Vogtle ESP Mandatory Hearing

NRC Staff Presentation Topic #7

Seismic Evaluation:

Geotechnical and Structural Engineering Review of Vogtle Limited Work Authorization

Dames and Moore EPRI Zones

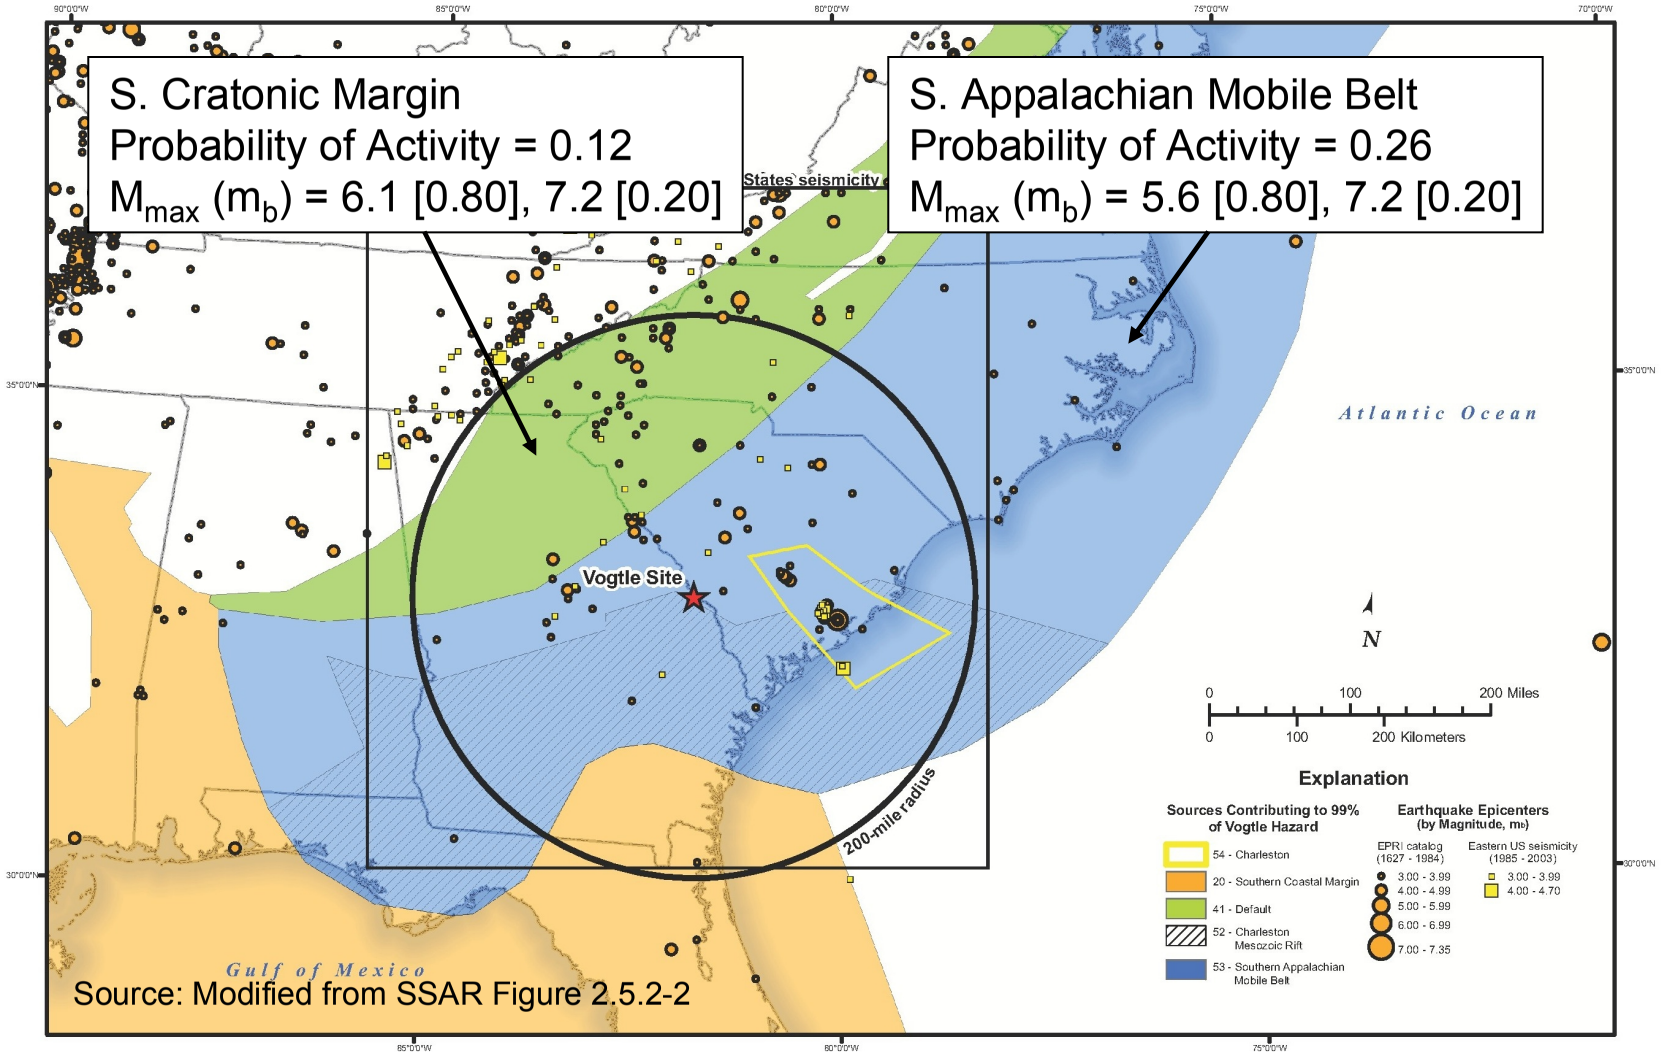
- **Regional Seismic Source Zone M_{max} and Probability of Activity**
  - EPRI seismic source zones were determined by six Earth Science Teams during the 1980s.
    - Dames and Moore team assigned low weights for larger M_{max} values (and low probabilities of activity) to two of their regional source zones.
  - The staff was concerned that the Dames and Moore hazard curves for the ESP site may not adequately characterize the regional hazard. (Open Item 2.5-1)

- **Regional Seismic Source Zone M_{max} and Probability of Activity (Cont'd)**
  - Applicant demonstrated that the contribution to the total seismic hazard from the Dames and Moore team is insignificant at the Vogtle site.
    - The increase in seismic hazard is less than ~5 percent if the Dames and Moore results are excluded.

Results of Staff's ETSZ Sensitivity Study

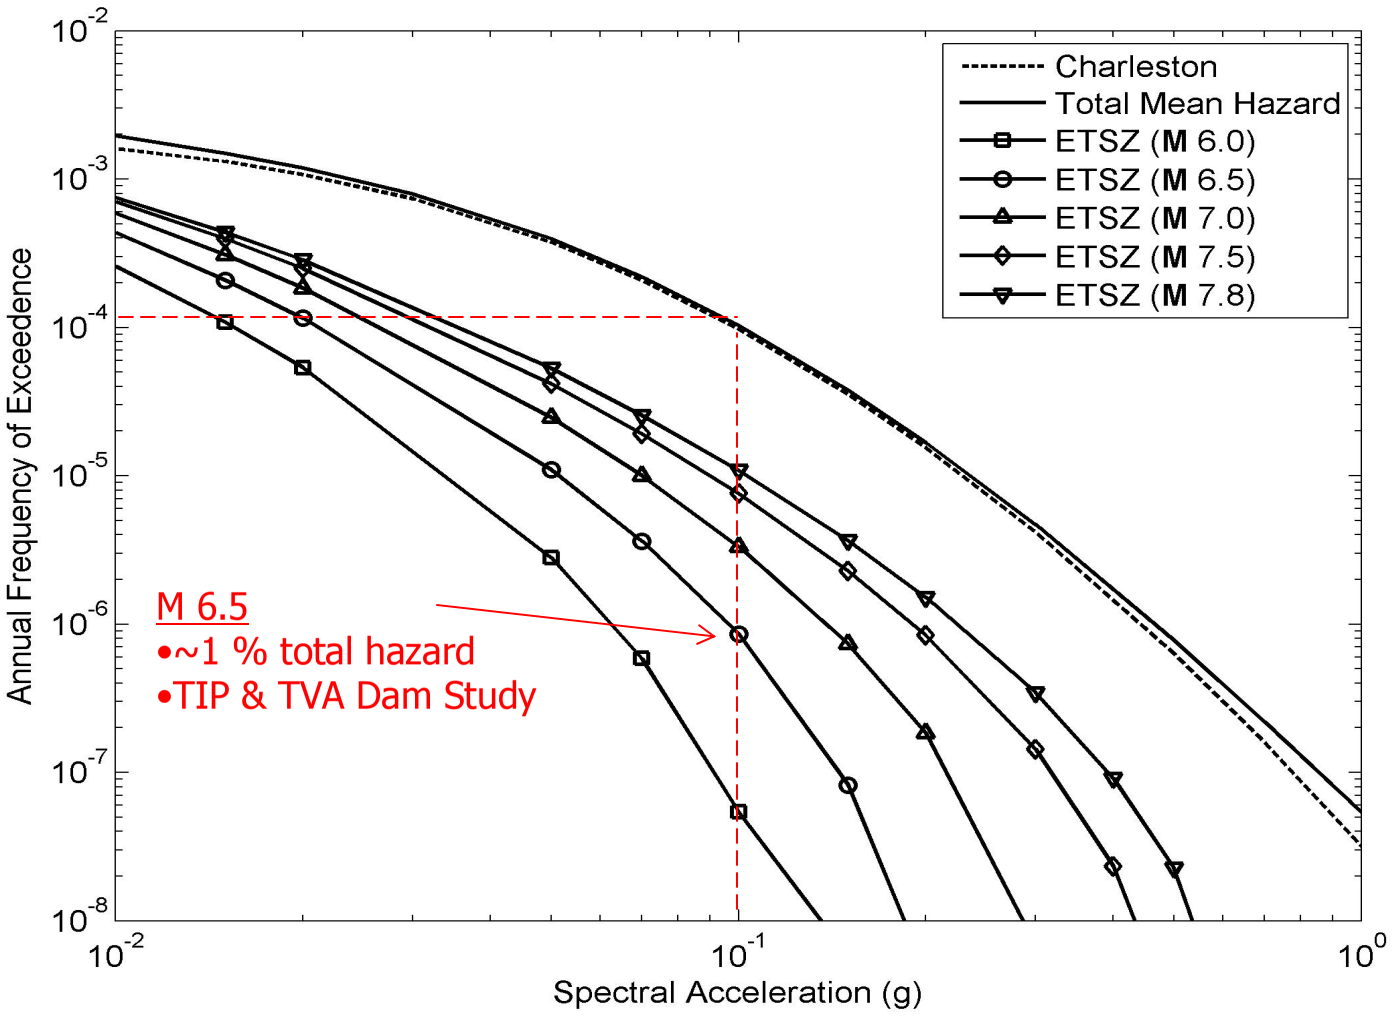
- **Eastern Tennessee Seismic Zone**
  - Applicant concluded no new information has been developed since 1986 that would require significant revision to the EPRI seismic source model.
    - More recent studies suggest revisions to the EPRI seismic source model may be warranted. (Open Item 2.5-3)
  - Staff's sensitivity study showed that the increasing ETSZ M_{max} did not result in a significant increase in the Vogtle total site hazard.
  - Staff determined that the results of the sensitivity study were sufficient to close out Open Item 2.5-3.

Applicant identified the GMRS as a site characteristic

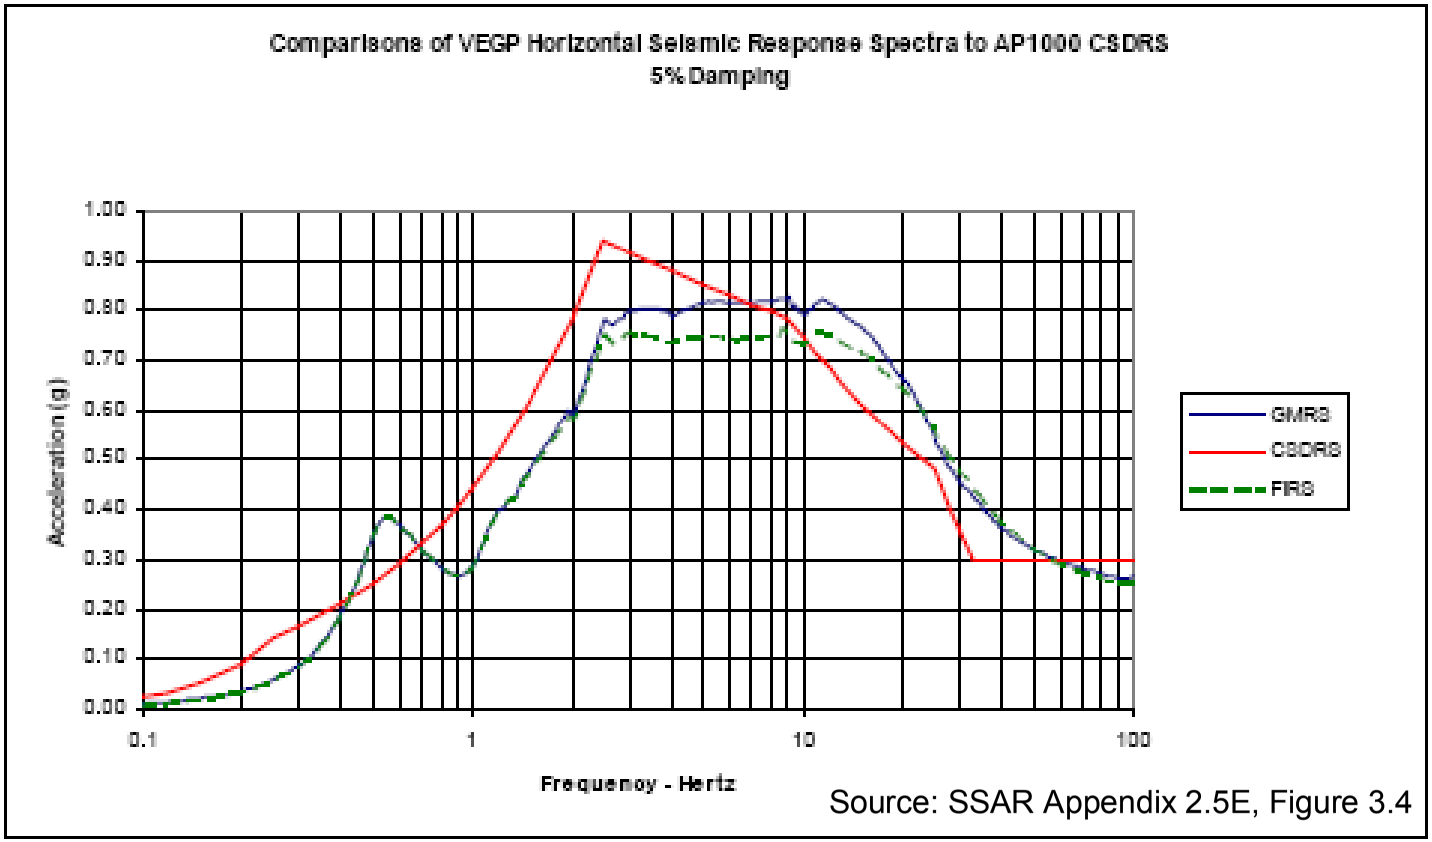
- **The site-specific GMRS is not bounded by the AP1000 CSDRS.**
  - Staff concludes Vogtle GMRS is an adequate representation of regional and local seismic hazard and meets the applicable requirements of 10 CFR Part 52 and Part 100.
  - Staff considers the Vogtle GMRS values to be within the range of values that new reactor designs generally are engineered to withstand.
  - Appropriateness of the reactor design chosen for the site will be determined at the COL stage.

Shear-Wave Velocity Profile

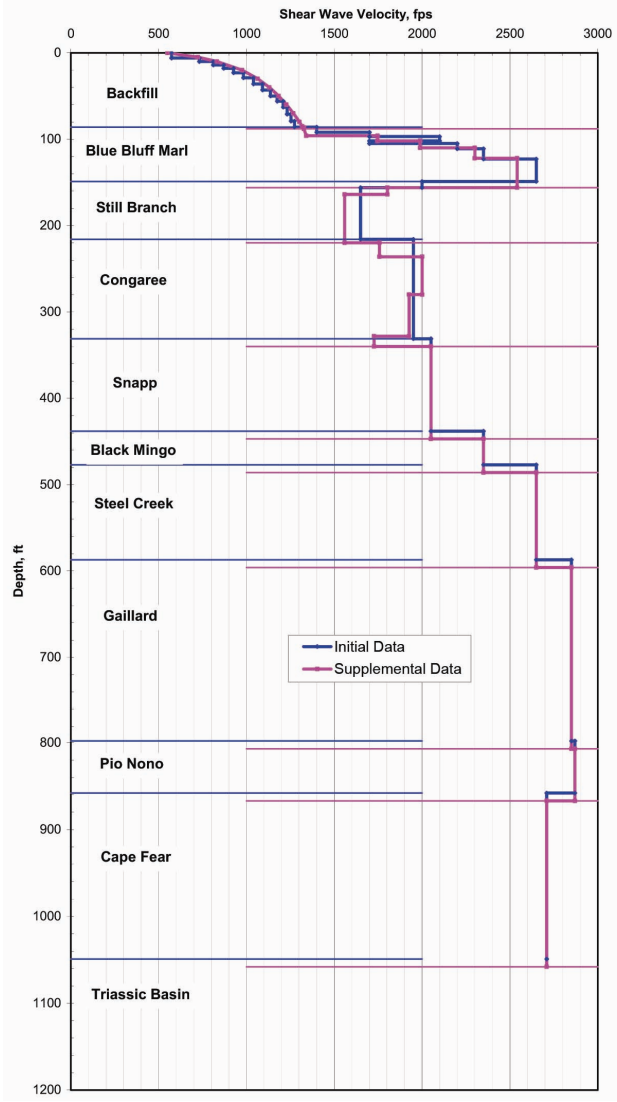
- **Shear-Wave Velocity**
  - Applicant provided insufficient shear-wave velocity measurements to define site characteristic values. (Open Item 2.5-18)
  - The applicant used additional data to re-evaluate the ESP profile following more detailed site investigations sufficient to close the Open Item.

Comparison of Vogtle Horizontal GMRS and FIRS with AP1000 CSDRS

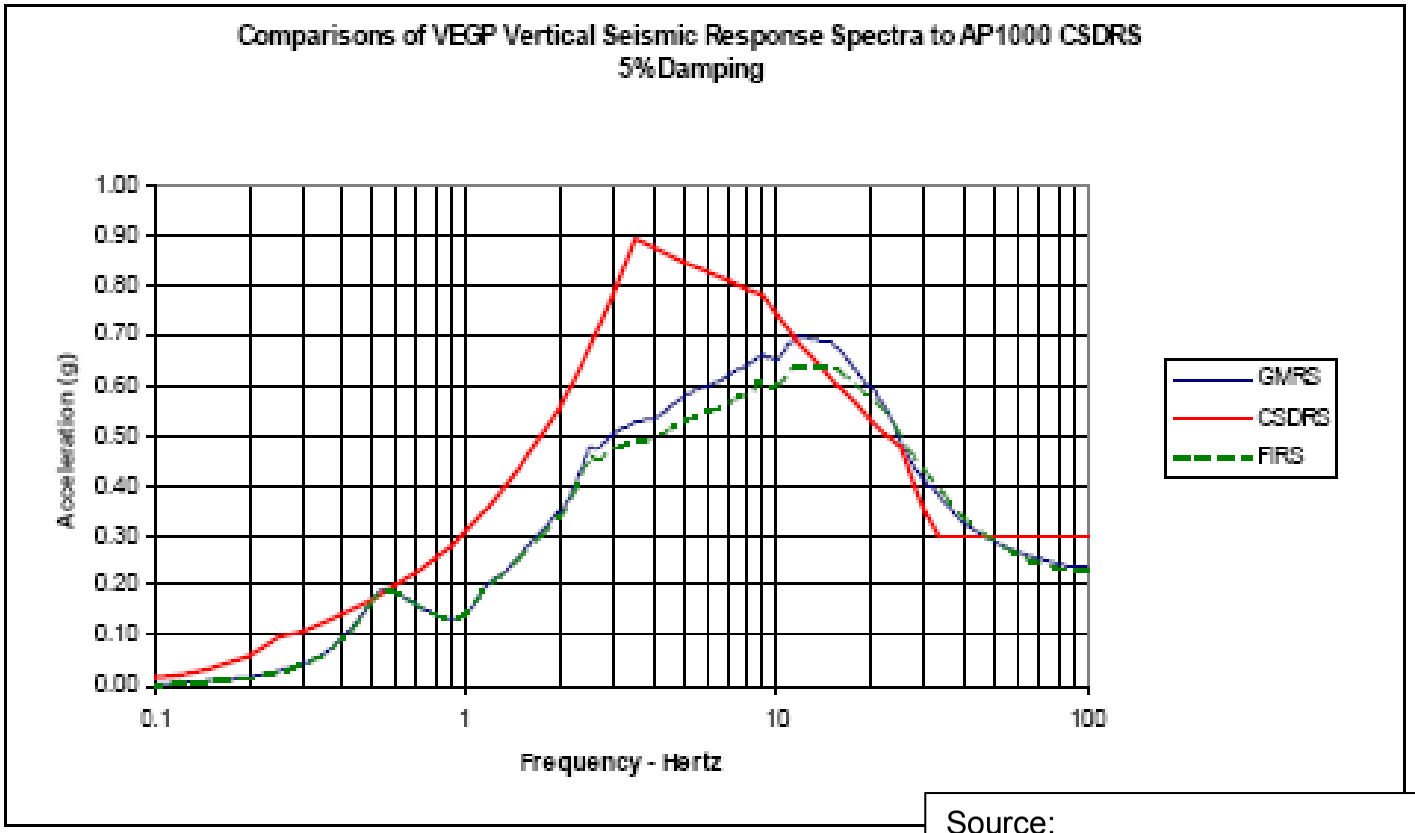
- Vogtle site GMRS exceed AP1000 Certified Seismic Design Response Spectra (CSDRS) in high and low frequency ranges (site-specific soil-structure-interaction analysis is required).
  - Required more in-depth staff review.
- Foundation Input Response Spectra (FIRS) defined at foundation elevation.

- Alternative method was used for developing the FIRS. Review indicates that the method results in a conservative estimate of horizontal seismic demand.

- The FIRS defined as an outcrop motion in the free field satisfied the minimum peak ground acceleration (PGA) value of 0.10g (10 CFR Part 50, Appendix S).
